STAFF BRIEFING PACKAGE

UPDATE ON PETITION CP 13-1,
PETITION REQUESTING A BAN OR STANDARD ON ADULT PORTABLE
BED RAILS

JULY 15, 2020

SUBJECT: Update on Petition CP 13-1, Requesting a Ban or Mandatory Standard on Adult
Portable Bed Rails

Figure 2: Zone 3 Entrapment Test, Section 6.3.3 and 8.4.5.4(2) requirement difference – Highest point of the Test Probe vs Line on the Test Probe

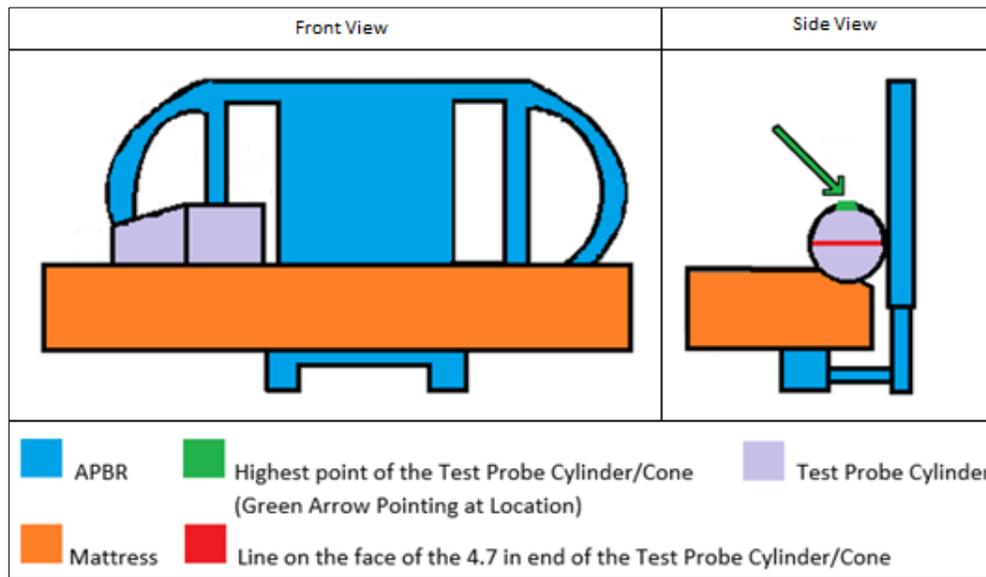
Although staff concludes that the ASTM F3186 – 17 performance requirements would adequately reduce the risk of injury and death associated with APBRs, staff believes that the language of some sections of the voluntary standard should be clarified to improve the likelihood that manufacturers will understand the requirements and test methods. The section 6.4.1 test requirement for finger openings refers to two different sets of diameters in two different unit systems. In addition, Section 6.3.3 states that for entrapment zone 3, the highest point on the cylinder of the test probe must remain at or above the uncompressed mattress plane. In contrast, section 8.4.5.4(2) states that a product shall fail the zone 3 entrapment test when the probe’s center line is at or below the surface of the mattress. Accordingly, staff notes that these two requirements are inconsistent about the distance the test probe can travel, whether the entire height of the probe, or only half of the height. Figure 2 illustrates the difference between the requirements. Staff believes section 6.3.3 should be revised to refer to the probe’s horizontal line, the halfway height. Consequently, on September 5, 2019, staff sent the chairman of the ASTM subcommittee a letter discussing these issues and proposed potential solutions.¹⁸ Staff met with the ASTM subcommittee to review the letter on June 12, 2020. The subcommittee agreed that changes to the standard were needed, and indicated that working groups would be established after updated incident data is provided and analyzed.

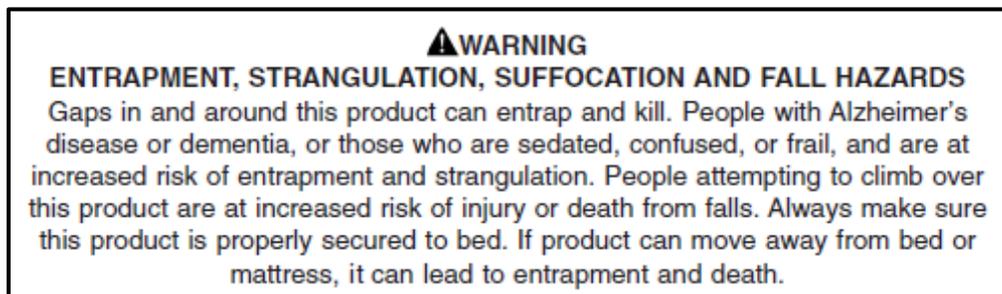
This warning is intended primarily to communicate, at the point of purchase, the potential hazards associated with APBRs, to improve the likelihood that consumers will purchase the correct product for their needs. The warning identifies the entrapment-related hazards associated with gaps in and around the APBR, and it emphasizes that consumers with Alzheimer's disease, dementia, or similar conditions are at increased risk of entrapment and strangulation. The warning also acknowledges the risk of injury or death from climbing over the product and falling. ESHF staff's review of the incidents revealed that few incidents involve the victim deliberately climbing over the APBR. However, staff agrees that alerting potential APBR purchasers about this potential hazard is valuable and may help consumers decide whether the users of this product might be prone to attempting this behavior.

ESHF staff acknowledges that certain aspects of this warning could be improved. For example, staff believes that the initial hazard statement, or heading, could be reduced from, "ENTRAPMENT, STRANGULATION, SUFFOCATION AND FALL HAZARDS," to the more concise, "ENTRAPMENT AND FALL HAZARD." In addition, staff questions the need for the final two sentences of the warning, which address proper installation. This information seemingly is not needed at the point of purchase. Lastly, there might be some benefit to rewording the warning to state explicitly that consumers should not purchase the product if the end-user is likely to engage in behavior that could put them at risk, such as trying to climb over the product.

Figure 1. Zone 3 Entrapment Test – Highest point of the Test Probe vs Line on the Test Probe

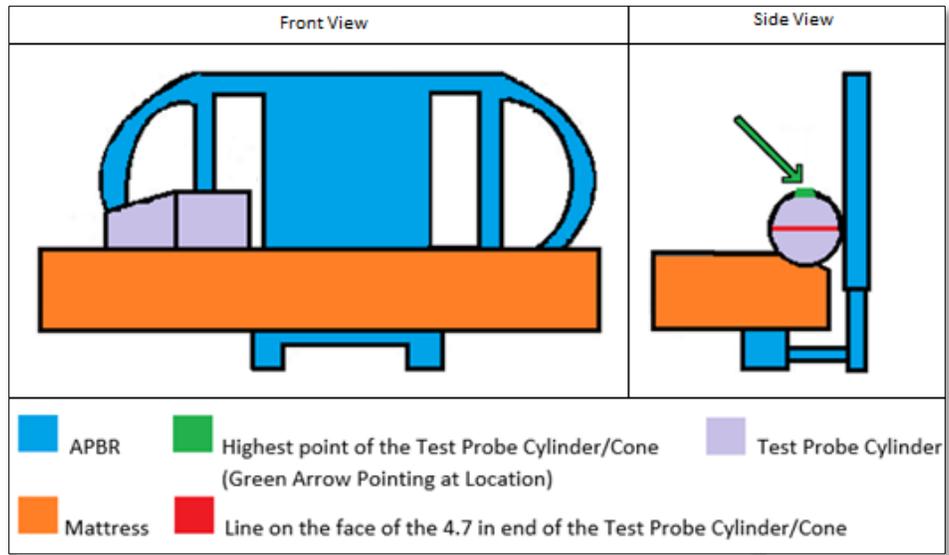
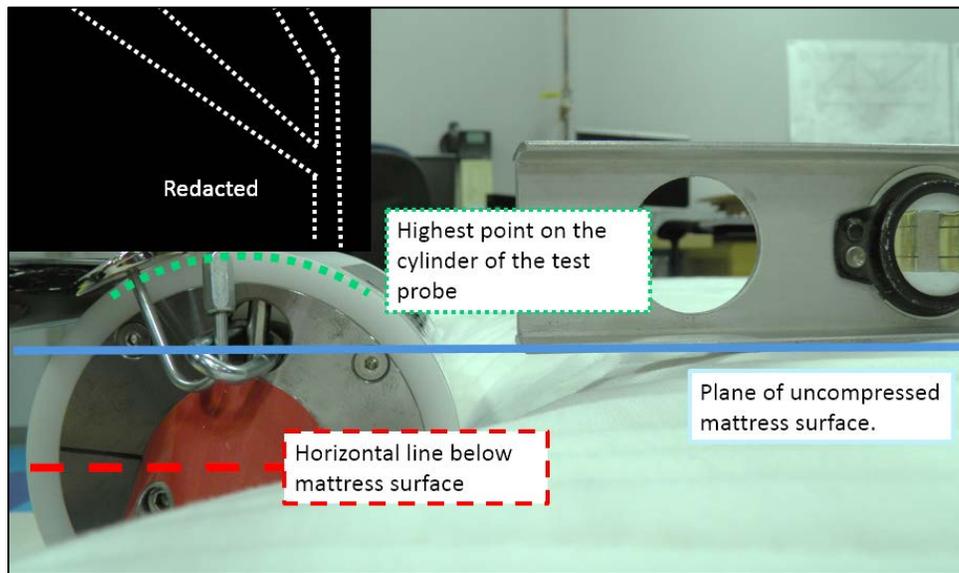
Staff identified two issues with the standard. The first issue concerned an internal inconsistency between the Zone 3 entrapment performance requirement and the performance requirement listed within the Zone 3 entrapment test methodology.^{6,7,8} ASTM F3186 – 17 Section 6.3.3 states that the highest point on the cylinder of the test probe must remain at or above the uncompressed mattress plane, when tested in accordance with section 8.4.5. However, the test method specified in section 8.4.5 states that a product shall fail the Zone 3 entrapment test when the horizontal line marked on one face of the probe is at or below the surface of the mattress. As seen in Figure 1,

the two sections refer to two different locations. Furthermore, CPSC staff identified multiple instances during testing where the highest point on the probe remained above the uncompressed mattress plane, while the horizontal line finished below the surface of the mattress. For example, in Figure 2 – the highest point on the dotted green curve remained above the blue line at the same time that the dashed red line finished the test below the blue line.

Figure 2. Section 6.3.3 and Section 8.4.5.4(2) requirements are inconsistent.⁹

Due to this inconsistency, CPSC staff suggested two changes set forth below (A double underline denotes added text, while a strikethrough denotes removed text.)

Proposed 6.3.3: ~~Zone 3—The highest point on the cylinder of the test probe (see 7.2) shall not pass completely below the horizontal uncompressed plane of the mattress when tested according to 8.4.5.~~ If the line on the face of the 4.7 in. (120 mm) end of the cone is above the surface of the mattress, the space passes the test. If the line on the face of the 4.7 in. (120 mm) end of the cone is at or below the surface of the mattress, the space fails the test.

Figure 3. Number of Samples vs. Number of Sections Failed, all samples failed at least one section.

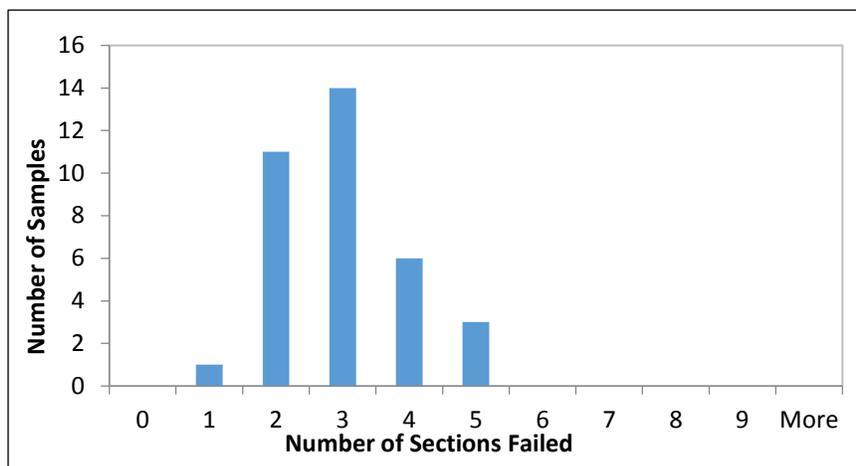
The physical testing resulted in a 100 percent failure rate, and most samples failed multiple sections, as seen in Figure 3. These results strongly indicate that APBRs on the market do not substantially comply with the voluntary standard.

Figure 5. Products did not extend at least 4 inches above the top surface of the mattress.

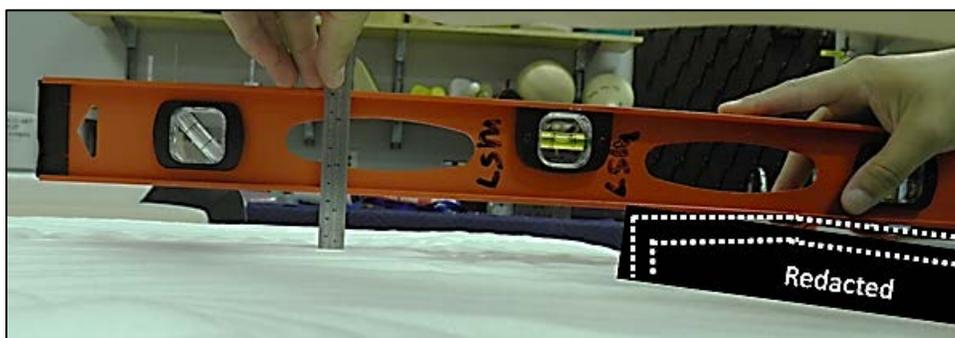
Section 6.2, *Structural Integrity*, has two main performance requirements: (1) during the static structural height test, the product shall extend at least 4 inches above the top surface of the thickest mattress recommended by the product manufacturer; and (2) the product shall not

change dimensions or create a hazardous condition during or after cyclic testing. A total of 43 percent of the market sample tested failed the structural integrity section, including 40 percent that failed the structural height requirement and 6 percent that failed a cyclic test requirement.¹⁴ Most manufacturers did not specify a recommended mattress height; in such cases, CPSC staff considered any mattress readily available to the general public. In addition, section 8.1 requires all products shall be tested fully assembled in accordance with the manufacturer's instructions, but several did not specify or instruct the user how to set the product's adjustable features. In the absence of direction from the manufacturer, CPSC staff adjusted the product's height to the most onerous detent, which was most often the lowest setting. As seen in Figure 5, this resulted in many products measuring a height less than the required 4 inches above the top surface of the mattress. For 6 percent of the samples tested, the fasteners loosened or detached during cyclic testing, which caused the product to change dimensions, as seen in Figure 6. This constitutes a failure under ASTM F3186 – 17 Section 6.2.2.

Figure 8. A product without sufficient Zone 1 internal structure.

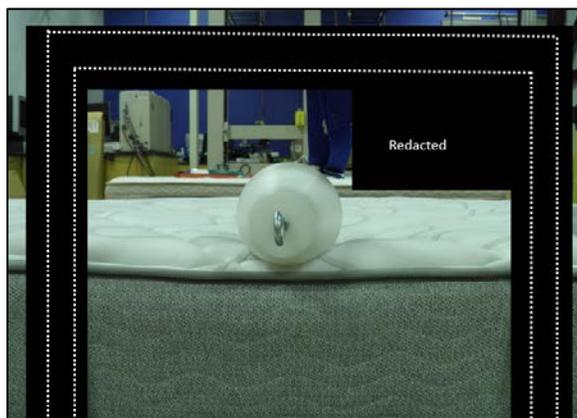
A total of 40 percent of the market sample failed the Zone 1 entrapment requirements. In the Figure 8 example, the samples did not have adequate internal structure to prevent the head probe from passing through a Zone 1 opening and failed the Zone 1 entrapment requirements.¹⁶

Figure 10. A product with a significant allowable lateral gap between mattress and product.

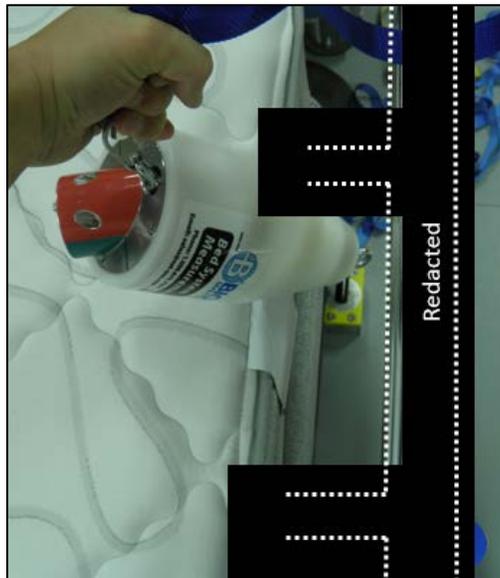
The second issue related to the lack of specificity in the information manufacturers provide. Many manufacturers did not specify what mattress thickness to use with the product; nor did they describe how the consumer is to appropriately install and/or adjust the product to fit different size mattresses. An example of a product with installation instruction that allowed for a significant lateral gap between the mattress and the product is shown in Figure 10.

Figure 11. The large gaps between the cross-beams allowed the probe to translate outward, which reduced the amount of mattress supporting the probe.

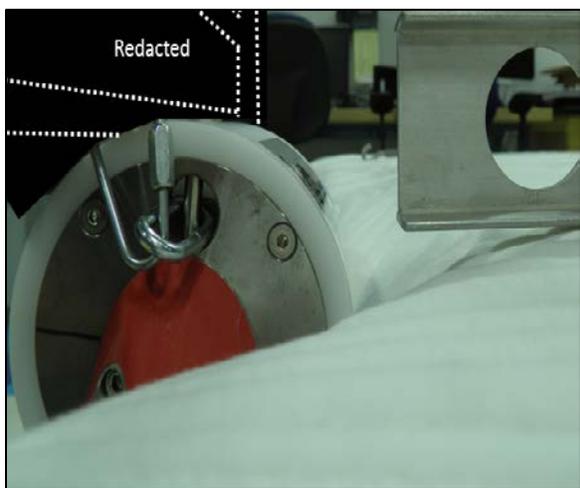
Approximately 31 percent of the market sample failed the Zone 3 entrapment requirements. The causes of the Zone 3 entrapment failures were similar to those listed for Zone 2. Most failures occurred due to a lack of adequate structure and issues with the lack of compatibility instructions, as noted earlier. In some cases, the gaps between the product's internal cross-beams were significant and allowed the probe to move laterally outward, partially into the gap between the cross-beams, which reduced the amount of mattress area supporting the probe, as seen in Figure 11. As the surface area supporting the probe decreases, the probe deflects more into the mattress, resulting in a failure related to the maximum allowable vertical deflection. One product used brackets that created a significant lateral space between the bed frame and the mattress and affected the distance between the product and a mattress. The significant gap between the product and the mattress allowed the probe to translate laterally outward, and reduced the amount of mattress supporting the probe, which reduced performance. As seen in Figure 12, the user manual also contributed to the lack of performance. Some user manuals do not explicitly state that the APBR should be installed against the mattress, and some of these include recommendations suggesting that this lateral gap can be as large as 2 inches. In addition, some user manuals that state that the APBR should be installed against the mattress also suggest that the distance between the product and the mattress could be as large as 2 inches, as large as 4¾ inches, or both. This issue is discussed in more detail in the Human Factors memorandum (Tab D).

Figure 14. Overhanging structure too high relative to mattress.

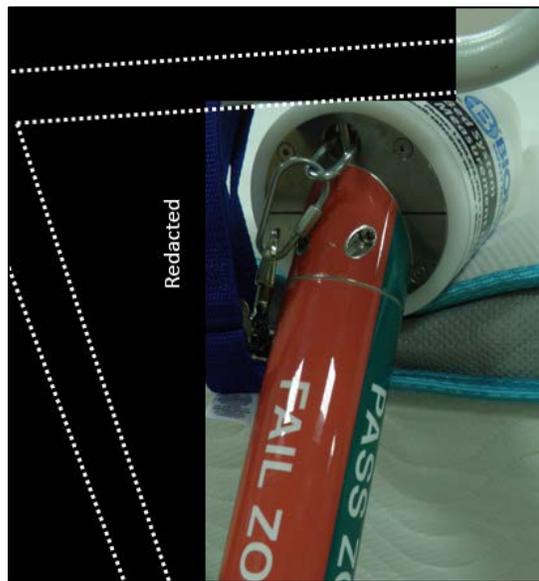
height, without saying why consumers should do so. In the absence of clear instructions from the manufacturer, CPSC’s technical staff chose to use a mattress available to the general public, with the product adjusted to any detent, as seen in Figure 14.

Figure 15. Label removed without damaging the substrate.

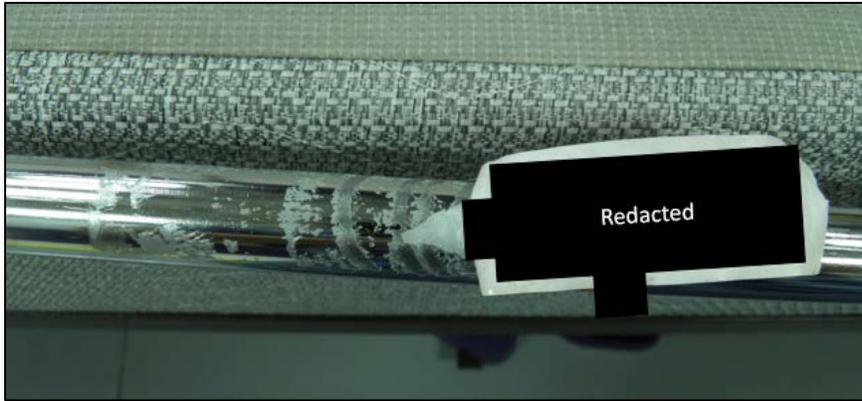
Section 9.1.2 *Label Permanency* required the warning labels to be permanent, irremovable without the use of solvents, tools or damaging the surface the label is on. In 54 percent of the market samples, CPSC staff removed a label without the aid of tools or solvents, and without damaging the substrate, as shown in Figure 15 below.
